Jeremy Smethurst WR summary, deadline 1

Please see attached my written representation for the 28th February deadline (deadline 1).

Screenshots of Google Maps showing A272 Traffic Problems

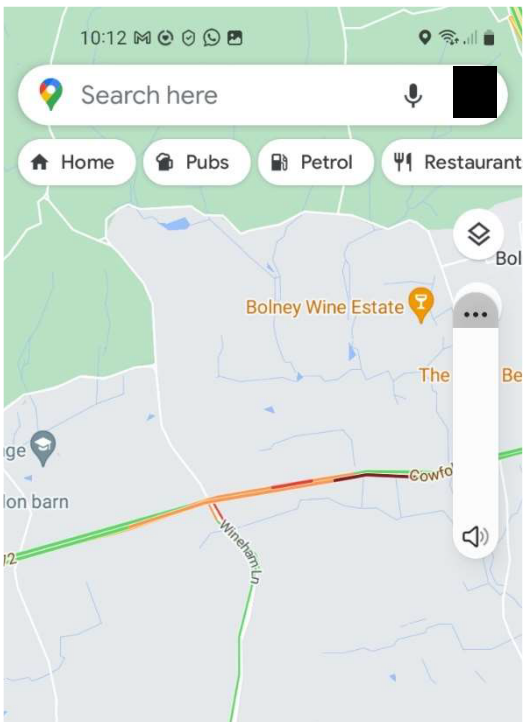
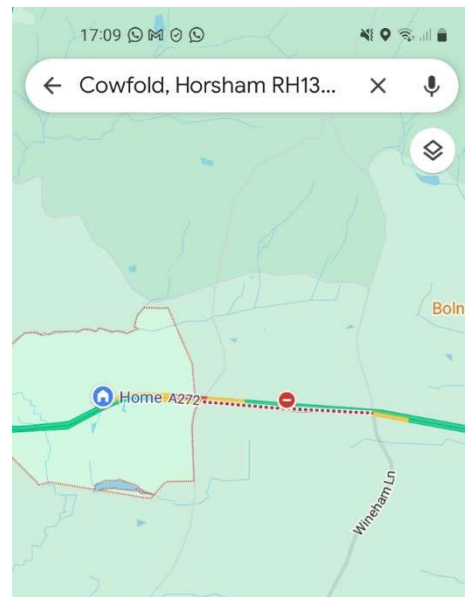
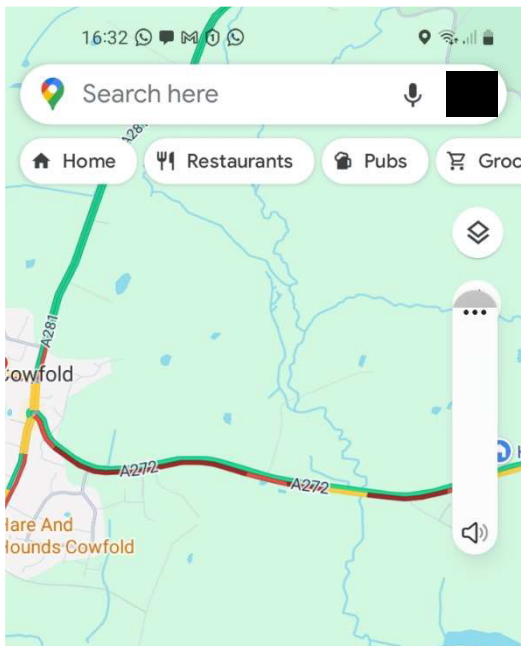
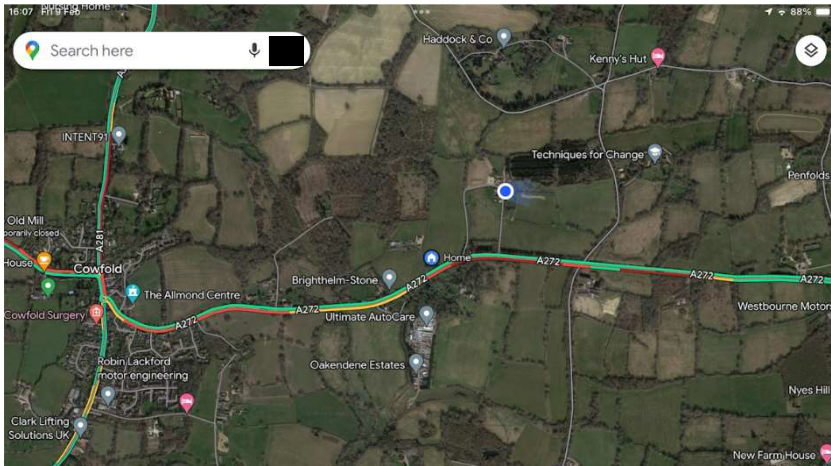
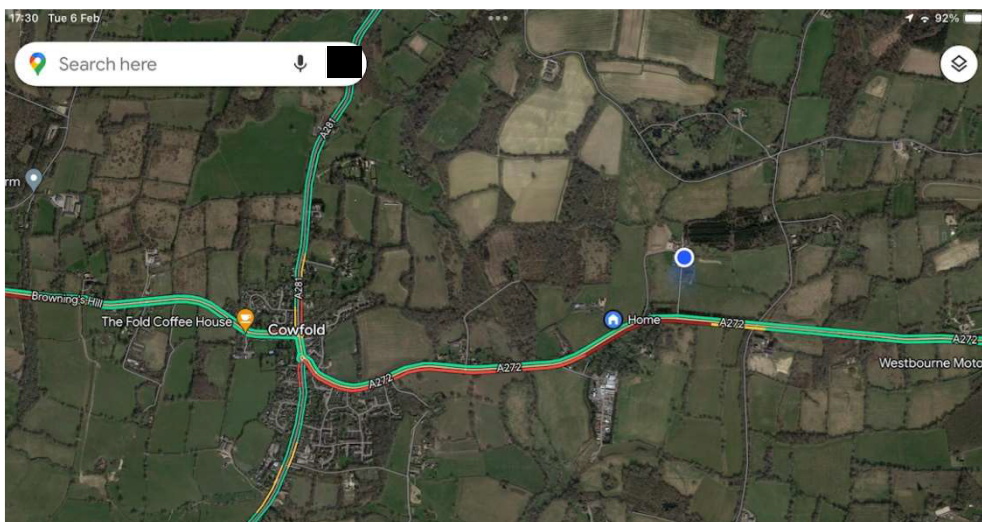
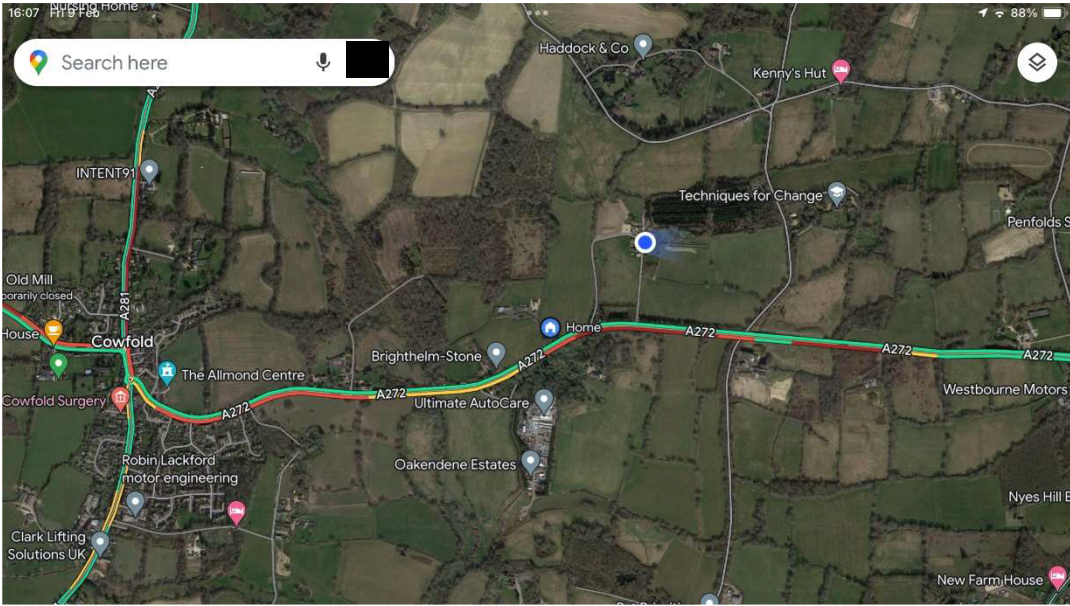
The A272 behaves quite differently approaching Cowfold compared to the section going through Bolney further east. You can see that residents there are far less affected by the traffic at Bolney by the fact that there was no mention of the A272 in the Rampion 1 consultation, or in fact, the current submissions from residents of Twineham, Wineham or Bolney. Congestion backs up to Kent Street and beyond at peak times and whenever there is anything affecting the flow of traffic, even a delivery vehicle. Screenshots of the congestion on this stretch show some examples of what happens, see below.
